Amended Second Floor Planning Drawing

PROJECT TITLE :
Proposed LIDL store on Richmond Road Twickenham

DRAWING TITLE :
GA Second Floor Plan

Proposed Second Floor Plan
Scale: 1 : 100

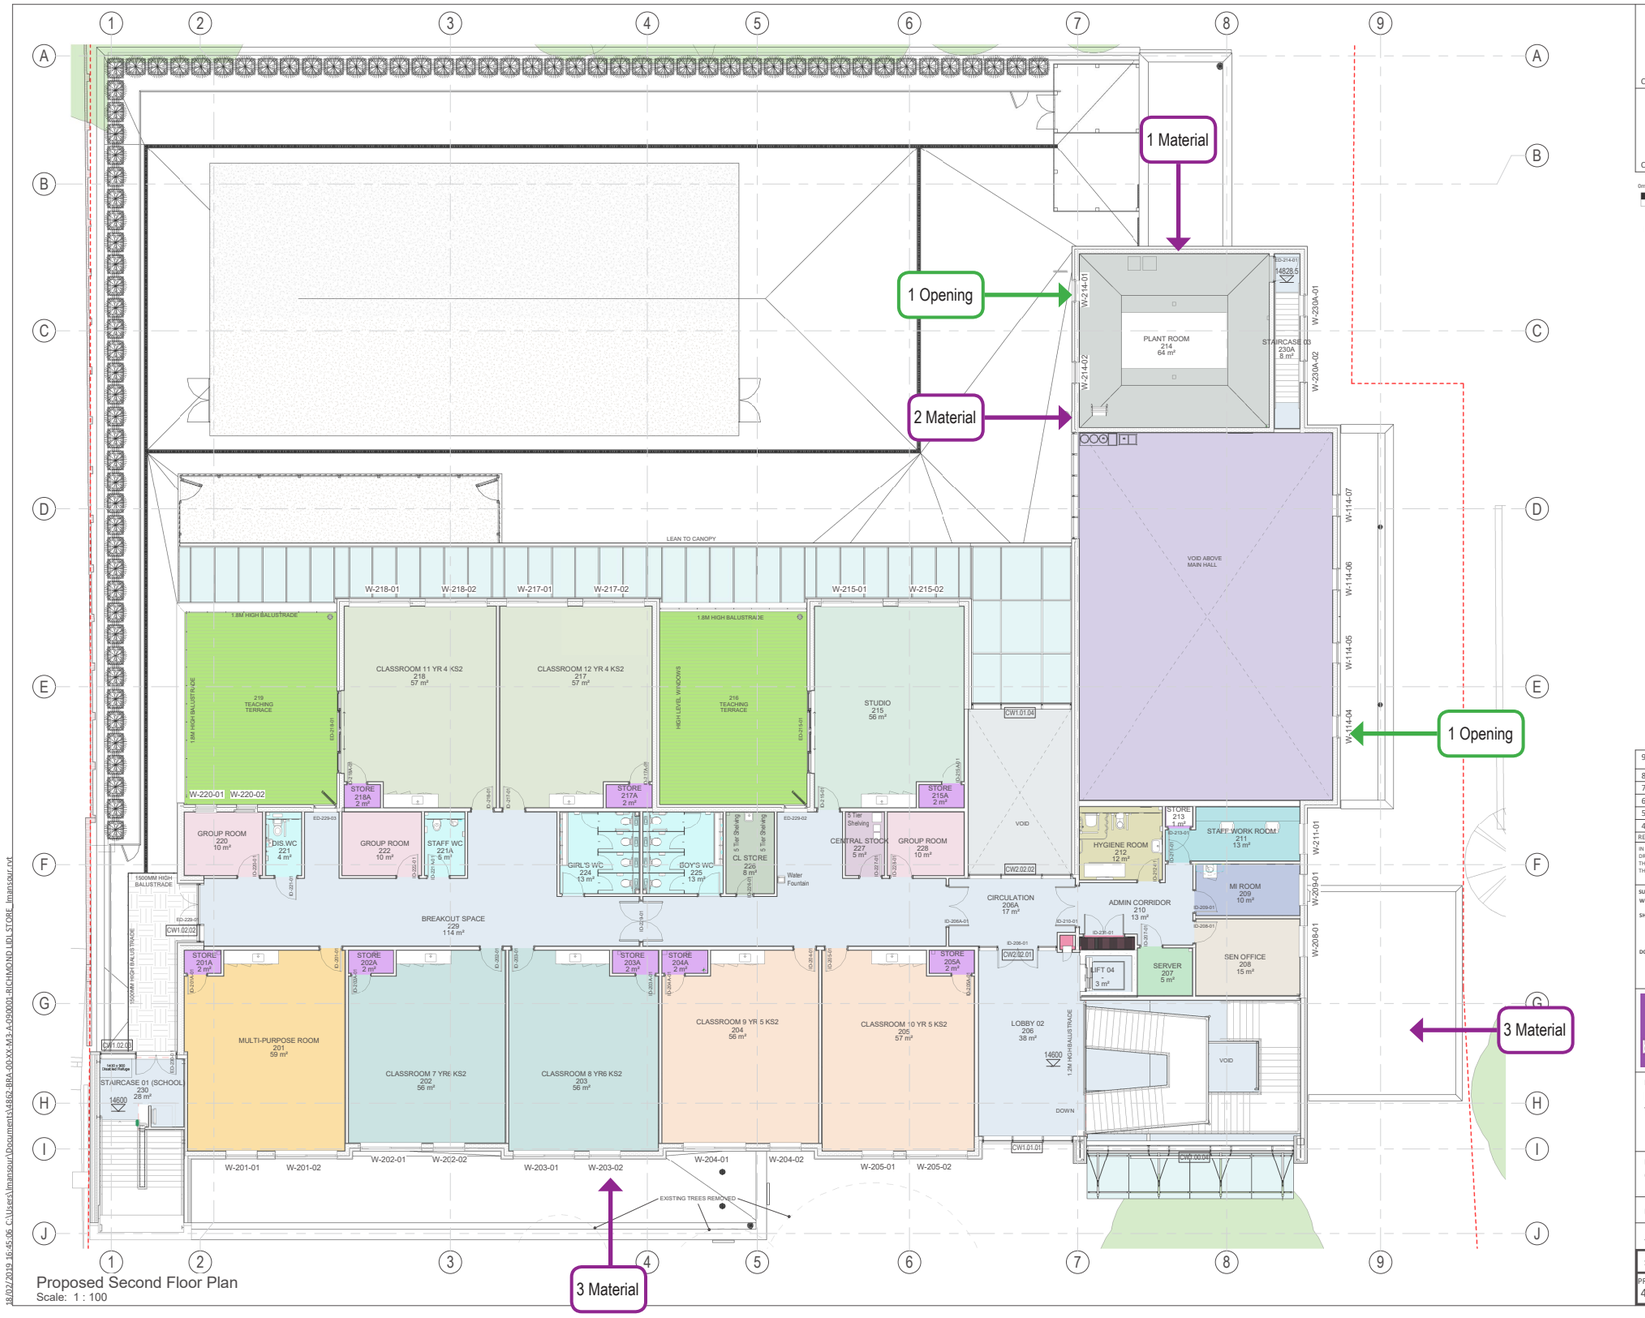
1 Proposed Change: Window / louvre design rationalised and aligned.
Reasons: Opening rationalized to suit revised elevation and CDM requirement.

1 Proposed Change: Cladding changed to render.
Reasons: Brick cladding replaced to reduce massing in combination with hall area.

2 Proposed Change: Cladding changed to brick.
Reasons: Render replaced to create differentiation with plant room.

3 Proposed Change: Green roof position moved to main roof level.
Reasons: Green roofs combined on top floor for improved maintenance access.
